Access Compliance Report

Public Rights-of-Way

(Curb Ramps)

Intersection ID: 14754	Main Street: SOUTH_BV	Cross Street: IVERSON_WY	Location: E
ADA ID: 4966117B6662	Ramp Type: Perp	Initial Pass/Fail: Fail	Overall Compliance: No
Severity Score: 21.25			
Codes/Mitigation Info/Possible Solution		Field Measurements/Component Compliance

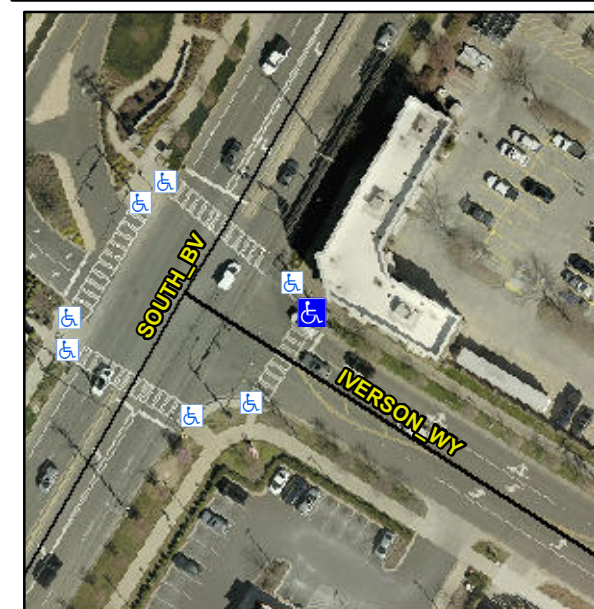
Not Found, R304.5.1, R304.2.2

Compliance	Description	Data	Compliance	Description	Data
N/A	Ramp Length (in)	69.0	No	Ramp Slope (%)	11.2
No	Ramp Width (in)	47.0	Yes	Ramp XSlope (%)	0.3
N/A	Flare Type LT	N/A	N/A	Flare Type RT	N/A
N/A	Flare Slope LT (%)	N/A	N/A	Flare Slope RT (%)	N/A
N/A	Flare Traversable LT?	N/A	N/A	Flare Traversable RT?	N/A
N/A	Landing Length (in)	N/A	N/A	DWS Provided?	N/A
N/A	Landing Width (in)	N/A	N/A	DWS Contrast?	N/A
N/A	Landing Slope (%)	N/A	N/A	DWS Length (in)	N/A
N/A	Landing X Slope (%)	N/A	N/A	DWS Full Width?	N/A
N/A	Landing Curb? (Y/N)	N/A	N/A	DWS Offset (in)	N/A
N/A	Shared Landing?	N/A			
N/A	Gutter Ponding?	N/A	N/A	Gutter Slope (%)	N/A
N/A	Gutter Lip Ht (in)	N/A	N/A	Gutter X Slope (%)	N/A
N/A	Painted X Walk1?	Yes	N/A	Painted X Walk2?	N/A
	X Walk 1 Direction	To SW		X Walk 2 Direction	N/A
N/A	X Walk 1 Width (in)	107.0	N/A	X Walk 2 Width (in)	N/A
	X Walk 1 Slope (%)	3.4		X Walk 2 Slope (%)	N/A
	X Walk 1 X Slope (%)	0.9		X Walk 2 X Slope (%)	N/A

Remove & Replace Entire Ramp.
